**6-10 CAMBRIDGE TERRACE AND 1-2 CHESTER GATE, CAMDEN, NW1
SECTION 73 OF THE TOWN AND COUNTRY PLANNING ACT 1990 (AS AMENDED)
APPLICATION FOR MINOR MATERIAL AMENDMENT TO PLANNING PERMISSION 2009/3041/P (AS
AMENDED)**

We write on behalf our client, Project Quad Limited, to seek approval of a Minor-Material Amendment (MMA) to the permitted scheme comprising works permitted by Planning Permission ref. 2009/3041/P and Listed Building Consent ref. 2009/3051/L and subsequently amended via a Section 73 application ref. 2015/1340/P and Listed Building Consent 2015/1817/L.

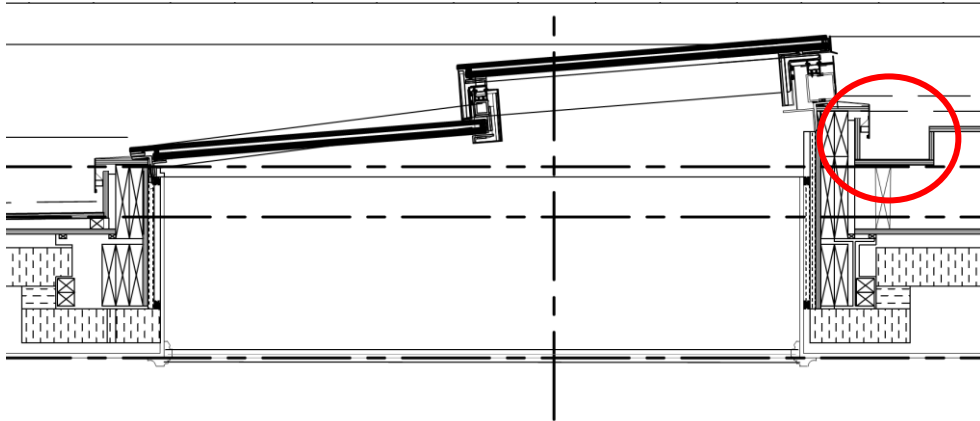
Due to Building Regulations, it has become necessary to make a further revision the proposed sliding roof light highlighted in red on drawing number SK02 – Roof Plan Key.

Building Regulations require roof lights to be proud of the prevailing roof plane by a minimum upstand of 150mm. This ensures that water ingress is prevented. The approved plans do not allow for this and thus the roof light cannot be constructed in its permitted form.

The new design approach means the full upstand height, required by building regulations, is achieved, with only a small amount of that height appearing above the prevailing roof line. This is achieved by 'sinking' the window into the roof plane and using a sunken 'gutter' around the top of the window to achieve the necessary upstand height.

An extract below from the proposed section highlights the design feature.
